Project	IEEE 802.16 Broadband Wireless Access Working Group < http://ieee802.org/16 >	
Title	Clarification to uplink data mapping for 2-antennas SS with matrix A for the optional PUSC permutation	
Date Submitted	2006-09-21	
Source(s)	Yang Hongwei, Li Dong, Cai Liyu Alcatel Shanghai Bell Co., Ltd. No. 388, Ningqiao Rd, Shanghai, 201206, China	Voice: +8621-28978243 Fax: +8621-50554554 [mailto:Hongwi.yang@alcatels-bell.com.cn]
Re:	IEEE 802.16e-2005	
Abstract	Editorial Corrections to Uplink Data Mapping for 2-antennas SS with Matrix A for the Optional PUSC Permutation	
Purpose	For consideration by the 802.16 Maintenance Task Group	
Notice	This document has been prepared to assist IEEE 802.16. It is offered as a basis for discussion and is not binding on the contributing individual(s) or organization(s). The material in this document is subject to change in form and content after further study. The contributor(s) reserve(s) the right to add, amend or withdraw material contained herein.

Clarification to uplink data mapping for 2-antennas SS with matrix A for the optional PUSC permutation

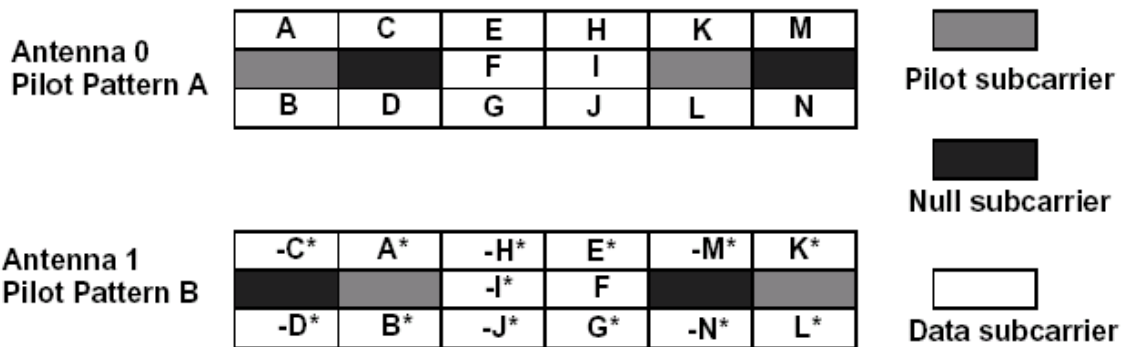
There exist two problems in Figure 251m in section 8.4.8.4.2, page 599, in IEEE 802.16e-2005 as following:

1. Wrong data mapping of symbols, more explicitly F, for STC using 2-antennas with matrix A for the optional PUSC permutation is shown.
2. Notation of pilot subcarrier and null subcarrier is not easy to differentiate.

[Change: Modify Figure 251m as following]
